**PRODUCT / PROCESS CHANGE NOTIFICATION**  
**PCN-000712**  
**Date: 12-29-2021**

<b>Part Number(s) Affected:</b>  -TS30041-M000QFNR; -TS30041-M015QFNR; -TS30041-M018QFNR; -TS30041-M025QFNR; -TS30041-M033QFNR; -TS30041-M050QFNR; -TS30042-M000QFNR; -TS30042-M015QFNR; -TS30042-M018QFNR; -TS30042-M025QFNR; -TS30042-M033QFNR; -TS30042-M050QFNR;	<b>Customer Part Number(s) Affected:</b> <input checked="" type="checkbox"/> N/A
---	--

**Description, Purpose and Effect of Change:**  
 Add Carsem Ipoh to support production Assembly & Final Test)

**PCN No. 000712**  
**Qualification of Carsem Ipoh for TS3004X-M0XXQFNR products**

## Assembly Process Flow Comparison for CarsemSZ (Old) vs. CarsemIPH (New)

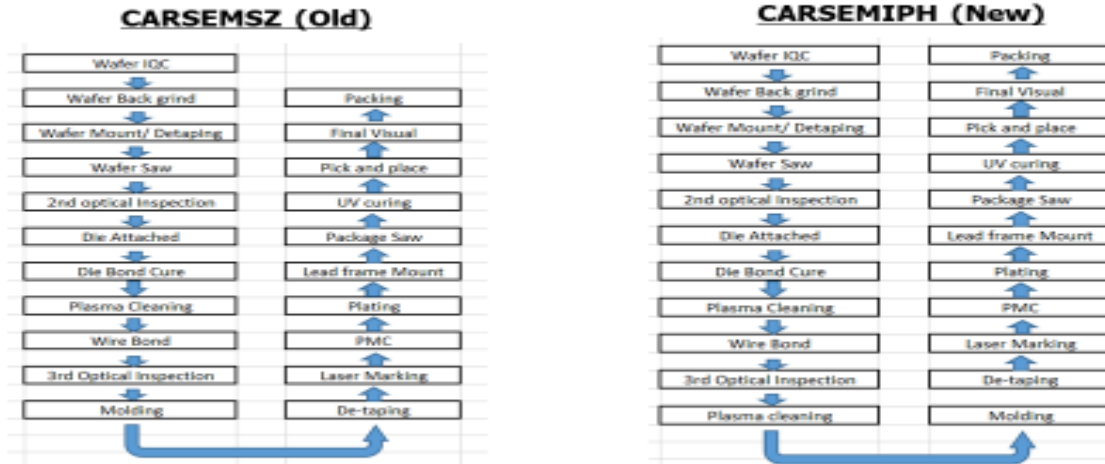
- No major Change in manufacturing Flow for both Assembly site CarsemSZ versus CarsemIPH except additional process step for plasma cleaning before mold for Carsem Iph.
